TECHNICAL ANNOUNCEMENTS NO. 04-2004

Object: control unit identification

Model: California MY03 kat

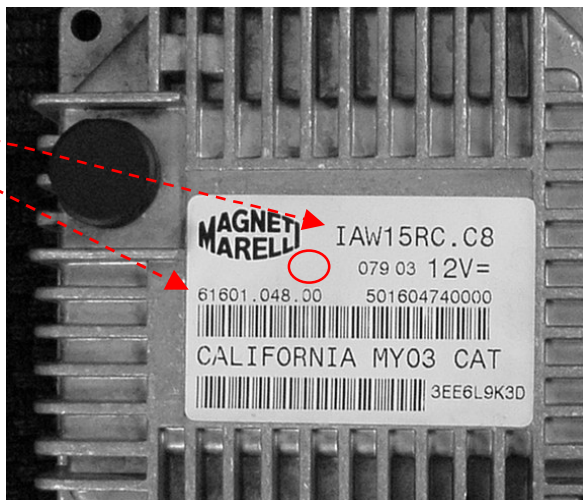
The serial number and the Magneti Marelli logo are printed on the control unit's label in the highlighted spots:

serial: IAW5RC.C8
 Magneti Marelli logo: 61601.048.01

the yellow mark can be on the label or on the control unit's body.

Should the control unit assembled on the vehicle be incorrect, replacing it is indispensable.
